Re: Underground Injection Control (UIC)  
Change in Maximum Allowable Injection Pressure  
Ute Tribal 29-12 Well  
EPA Well No. UT20736-04523  
EPA Permit No. UT20736-10000  
API # 43-013-31797  
Antelope Creek Oil Field  
Duchesne County, Utah

# **UIC ENFORCEMENT ROUTING AND TRANSMITTAL SLIP: UT20736-04523 Petroglyph revised MAIP**

Re: Underground Injection Control (UIC)  
Requirement to Conduct Step-Rate Test  
Ute Tribal 29-12 Well  
EPA Well No. UT20736-04523  
EPA Permit No. UT20736-10000  
API # 43-013-31797  
Antelope Creek Oil Field  
Duchesne County, Utah

The resultant step rate plot indicates a fracturing point intersection at:

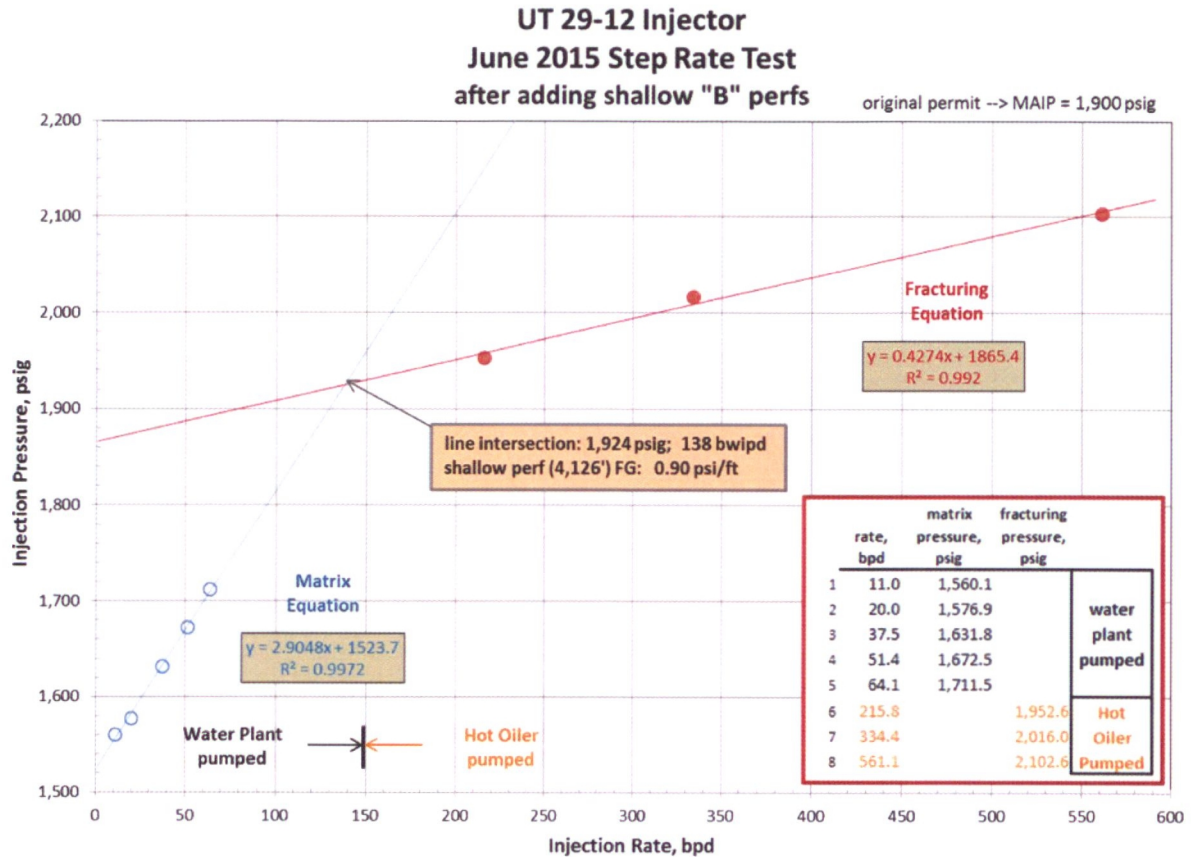
Based on the review of the data, EPA is not approving the step rate test results based on the following reason:

- A breakdown point was not observed in either event. Because of the two separate events, the result from Petroglyph appear as two disparate slopes used to extrapolate the fracture pressure. Additionally, experimental conditions (e.g., fluid characteristics) may have changed between the two testing events.

We would like to see the step rate test be retested with the following conditions:

- The step rate test is to be conducted where the plot of the pressure versus rate is experimentally collected in one continuous event, beginning from below the fracture parting pressure, through the breakdown point, and into the above fracture parting pressure.
- After additional discussion with others in the office, we would also like to see both surface and bottom-hole pressures to be observed during the step rate test.

On September 22, 2015, Petroglyph responded via email with an amended requested for a proposed change in MAIP to 1711 pounds per square inch, gauge (psig). This proposed value was requested because it was the highest stabilized matrix pressure observed during the step rate test and is thus still below the fracture pressure of the injection zone. The EPA has reviewed your request and concurs that the 1711 psig is an acceptable value for the MAIP.

Pursuant to Part II, Section C.5.b of the above referenced permit, the EPA hereby revises the MAIP for the Ute Tribal 29-12 injection well to not exceed 1710 psig. The determination is based on the highest stabilized matrix pressure observed during the step rate test, rounded down to an integer of five.

The resultant step rate plot indicates a fracturing point intersection at:

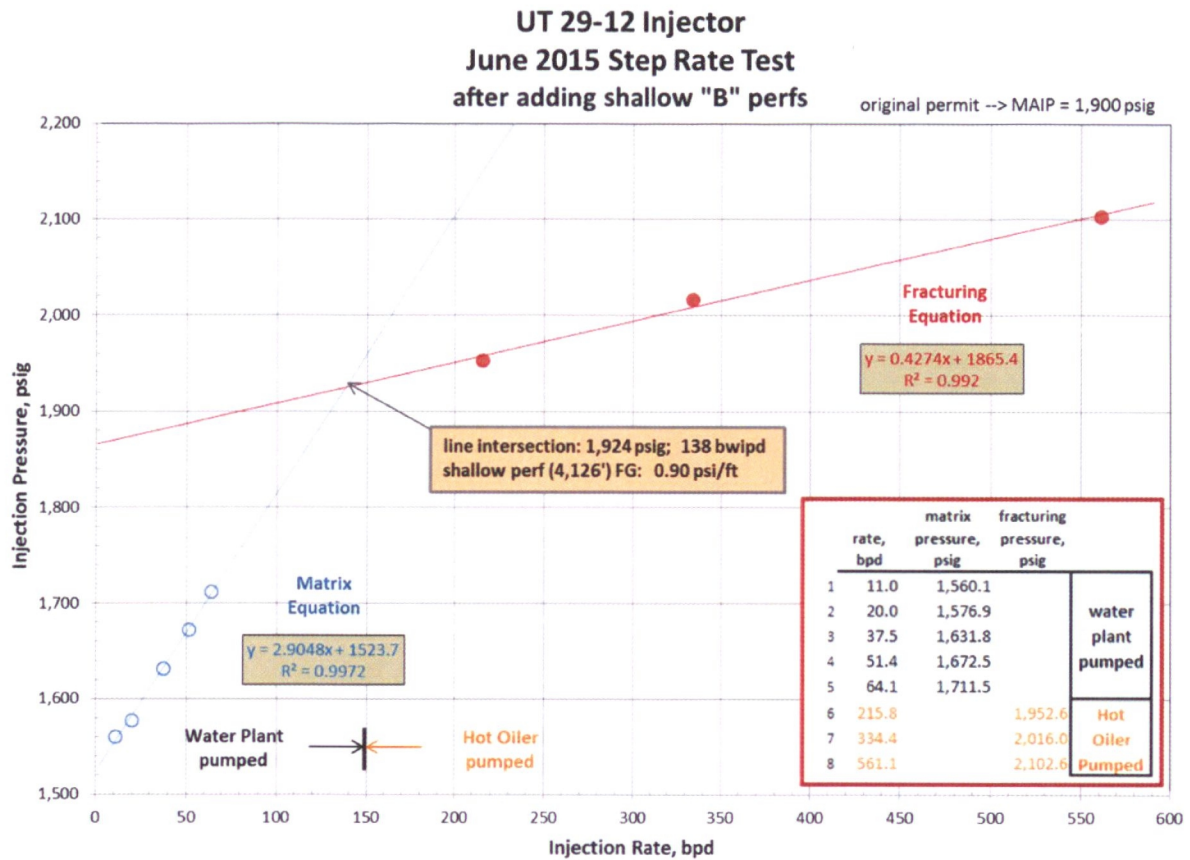
1. On our initial test using our water plant, the last point at 1711.5 psig was on the matrix trend line.
2. The first point on our test pumping water with the hot oiler at 1952.6 psig was not on the matrix trend line.

We would request an allowable injection rate of 1711 psig for the UT 29-12 injector, which is clearly on the matrix line. Since our plant can't pump steadily above this pressure at this location, this would be adequate for our present purposes. If we need to get a higher injection pressure, in the future, we will rerun the step rate test.
